SEWAGE DISPOSAL TESTING

STATE OF MARYLAND - DEPARTMENT OF HEALTH AND MENTAL HYGIENE

SUBDIVISION (Dickey Farms)

TITLE PERCOLATION TEST PLAT			
PROJECT LOT 28 - DICKEY FARMS			
LOCATION 3 rd ELECTION DISTRICT, HOWARD CO. MD.			
DATE: June 13, 1978	DESIGN BY: _____	DRAWN BY: WGH	CHECKED BY: _____
SCALE: 1" = 100'	JOB NO.: 78126	DRAWING NO.: 1 of 1	
boender associates		engineers surveyors planners	
BALTIMORE 301-485-7777 • SALISBURY 301-749-1286

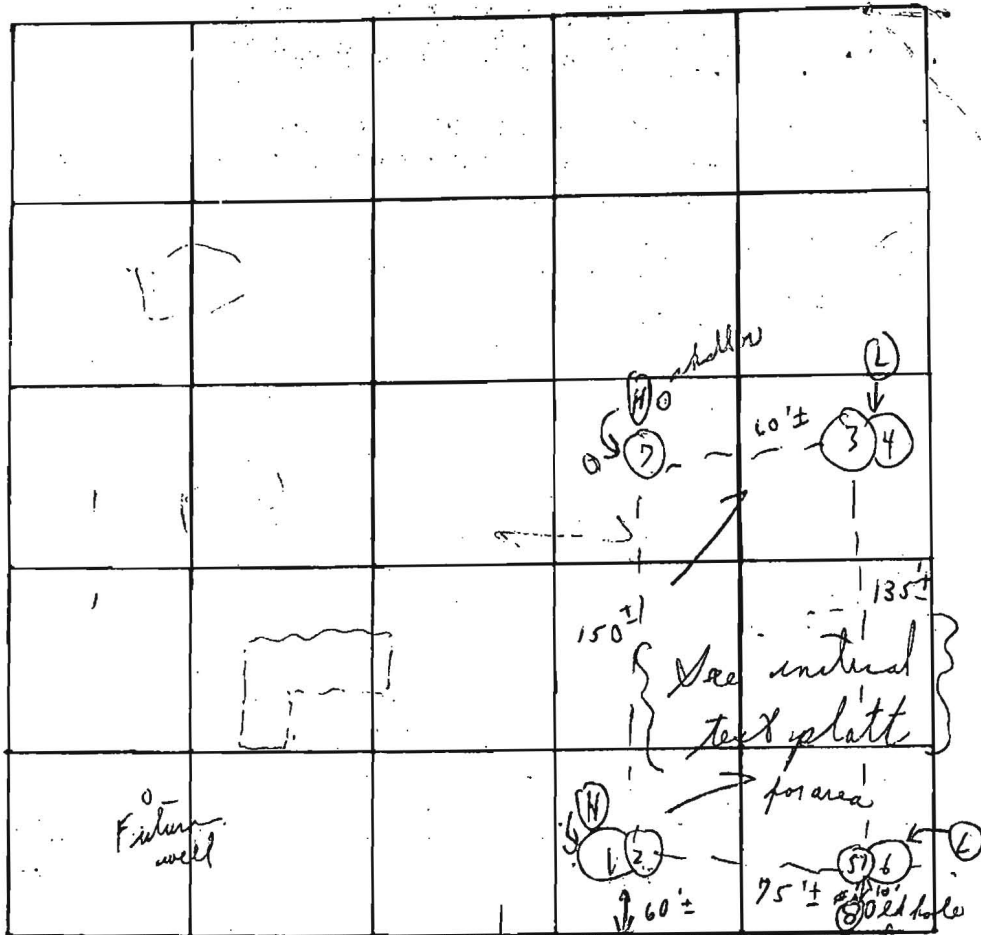
6/1/78 REASONS FOR REJECTION OR HOLDING certified holes in new area, + house plan spec written C.B.T.

dry well to have 170 sq. ft.

effective absorbent sidewall area per bedroom
below inlet. Inlet to be 3 1/2' below original grade
and maximum depth 12'. Location per plat. 75' from
front property line and 100' from right side line when
facing lot from front of property. If dry well & trench used need:
(1) 5' earth buffer between trench and dry well
(2) 2 inspections of trench - before and after stone in.

LOT NO. 28 (3) Trenches to run to rear of lot
